Service Bulletin

0019
08/15/03

Fuel Line Routing for Improve Flow

Affecting all Viper 50 & Viper 90 model years 2002-2004.

Fig #1

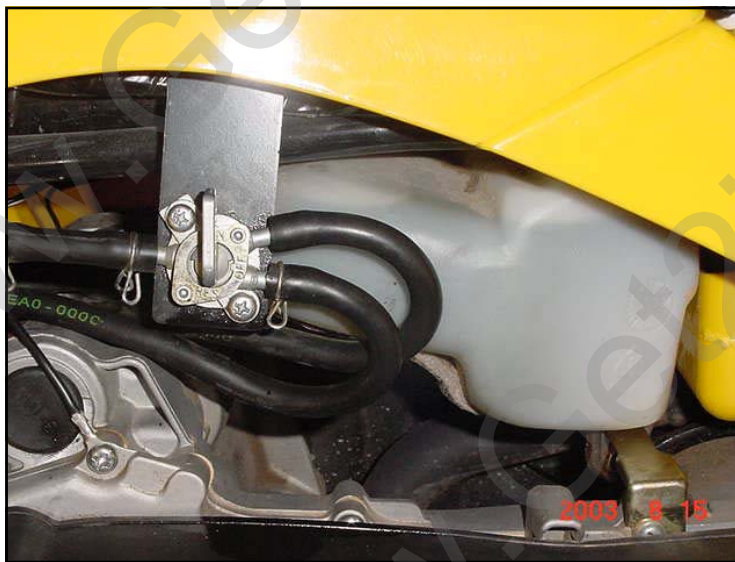
Check your fuel line routing. If the fuel lines are routed as in fig #1 you may have a fuel flow restriction.

To improved fuel flow we suggest that you reroute the fuel line as shown in fig #2.

Reroute the fuel line from the bottom of the tank to petcock along side the tank instead of over the tank.
